ADDENDUM NUMBER 1

Dated October 24, 2019

Cajalco Road Combined Projects
Mead Valley Area
Project No. C6-0060, Federal Aid No. HSIPL 5956 (253)
C7-0035, C8-0079 and ZDST10

SHEET No. C-10
 SHEET 25 OF 48

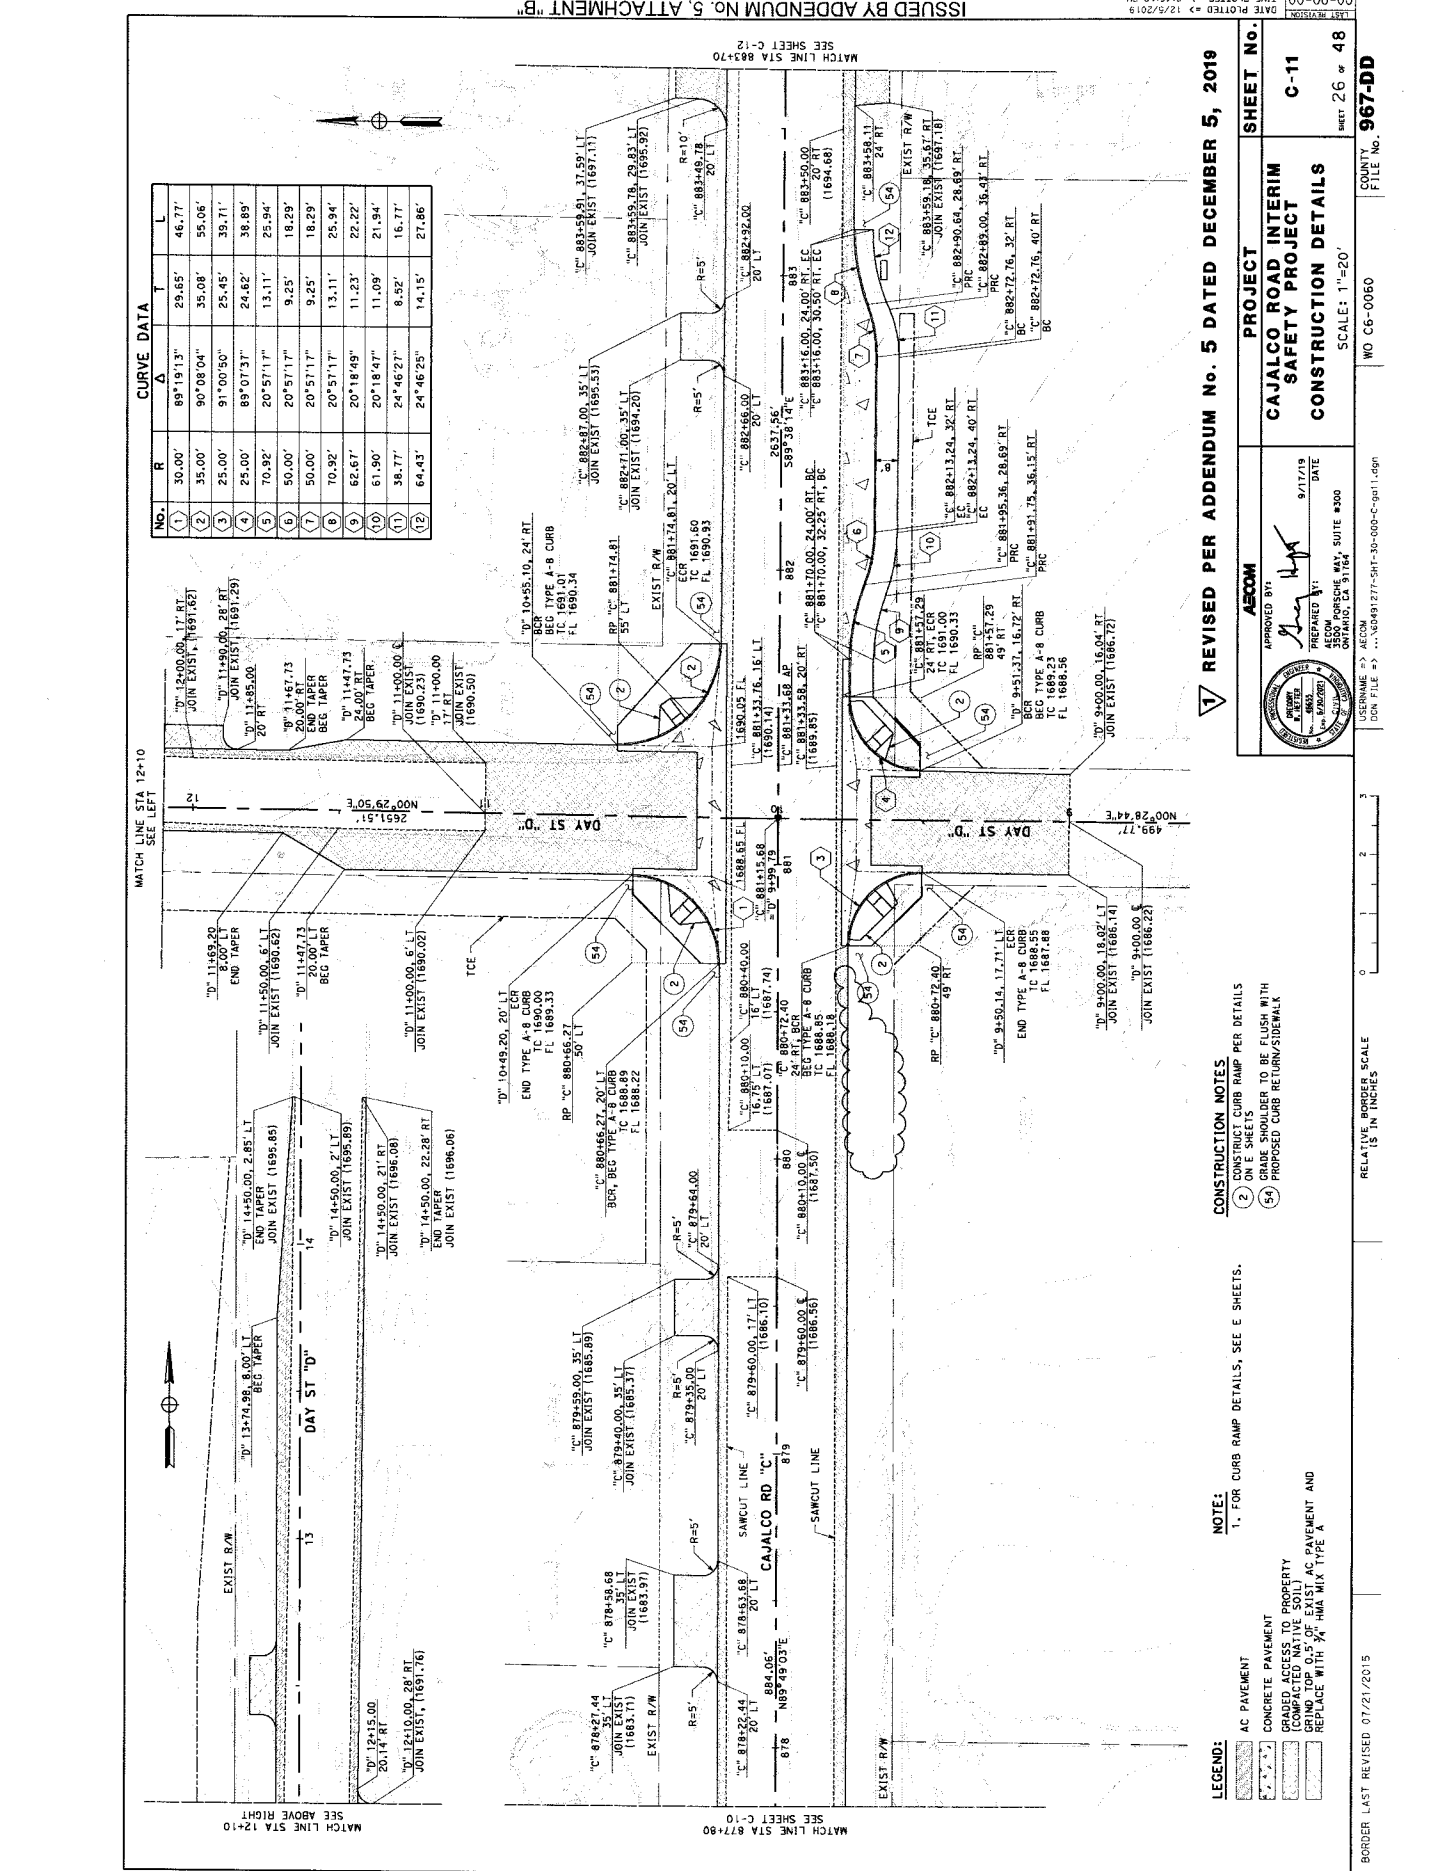
19. Plan sheet 25 of 48, C-10; added curb ramps and curb ramp details.
20. Plan sheet 26 of 48, C-11
21. Plan sheet 28 of 48, C-13; deleted Details 2, 3, 4, 5 and 6. Revised Detail 1.

APPROVED BY: <i>[Signature]</i> PREPARED BY: <i>[Signature]</i> DATE: 9/17/18 REVISION: 1 DRAWING NO.: 18-000000-01 PROJECT: CAJALCO ROAD INTERIM SAFETY PROJECT	SHEET No. 48 DG-1 SHEET 29 OF 48
--	---	---

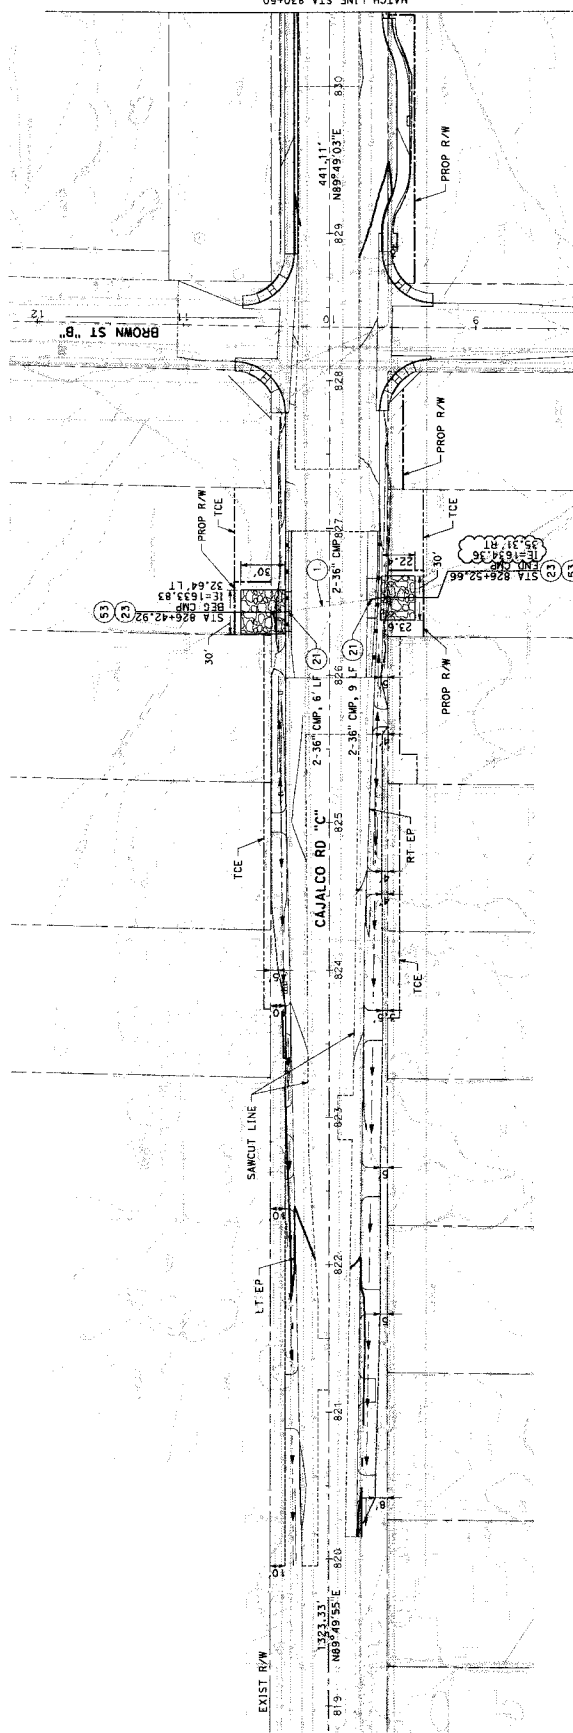
22. Plan sheet 29 of 48, DG-1; revised invert elevation.
23. Plan sheet 30 of 48, DG-2; deleted earthen ditch and overside drain on north side of Cajalco.

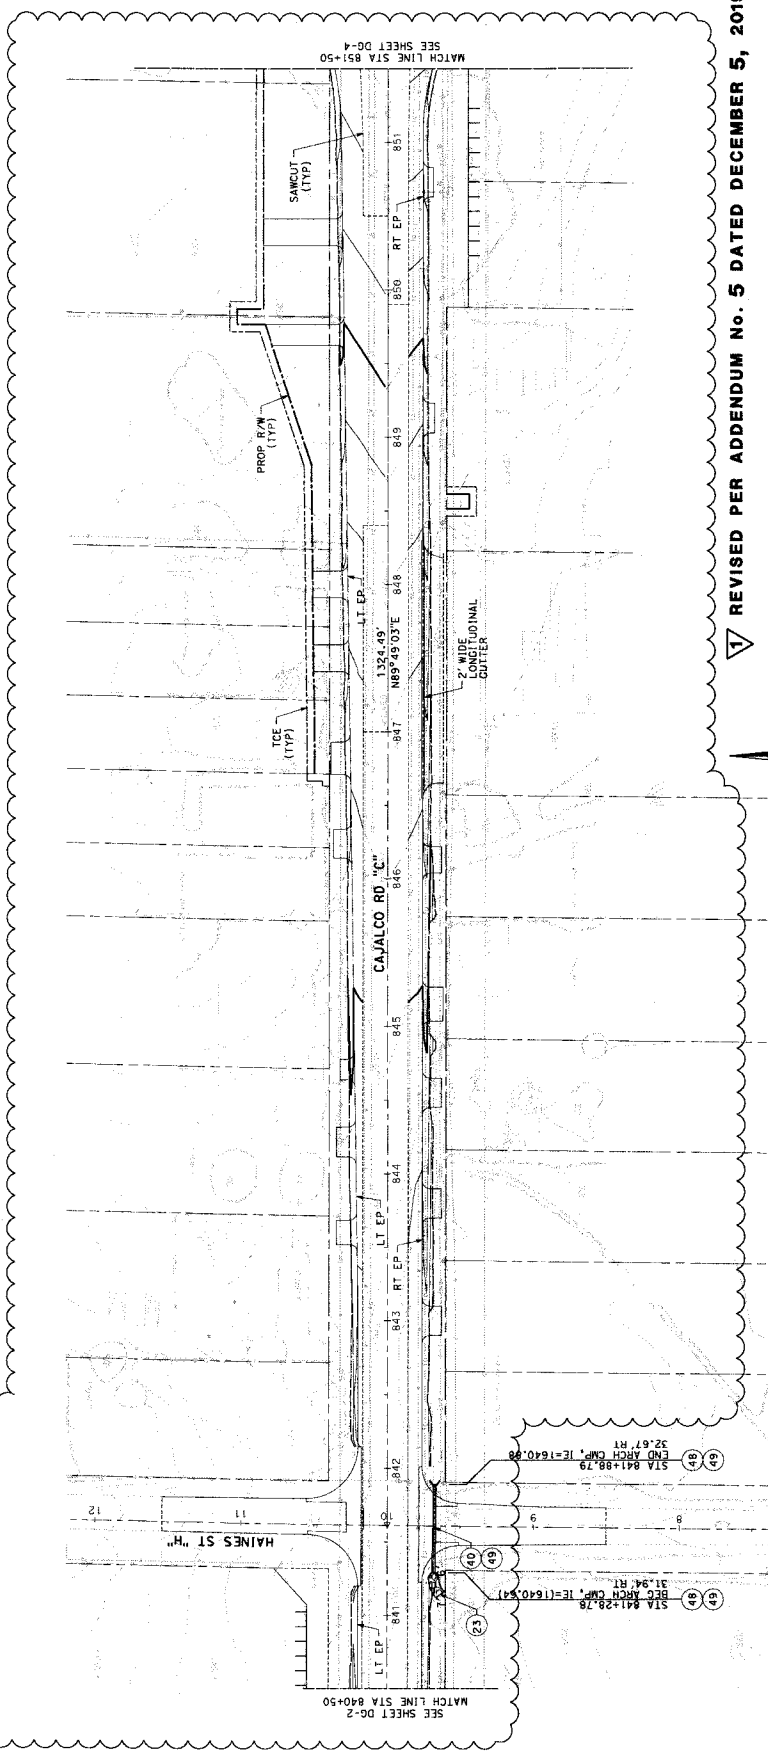
24. Plan sheet 31 of 48, DG-3; deleted earthen ditches and overside drains.
25. Plan sheet 32 of 48, DG-4; deleted earthen ditches.
26. Plan sheet 33 of 48, DG-5; deleted earthen ditches and overside drains.

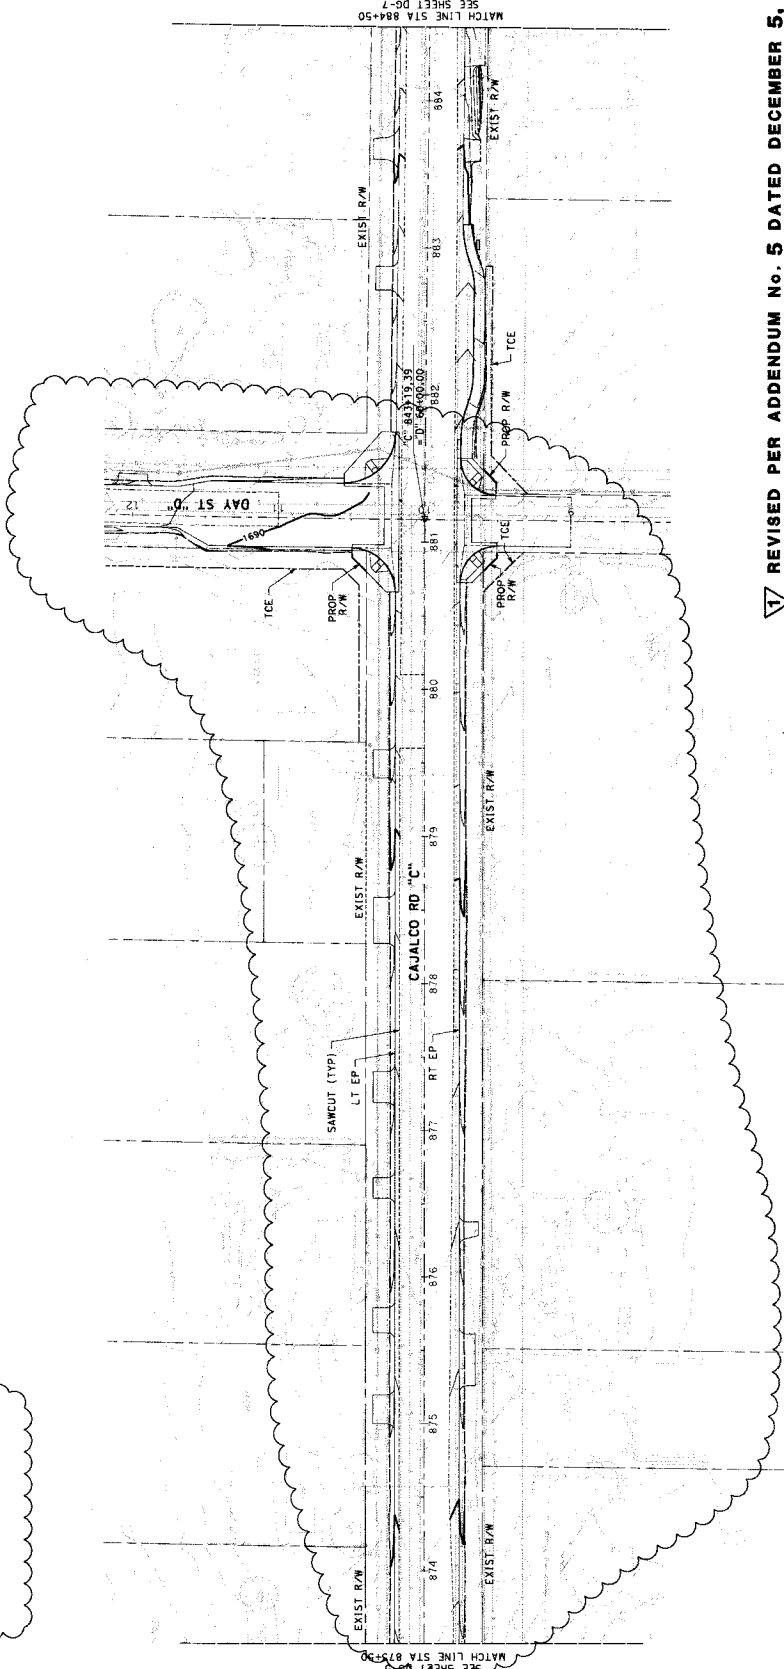
27. Plan sheet 34 of 48, DG-6; deleted earthen ditches and overside drains.
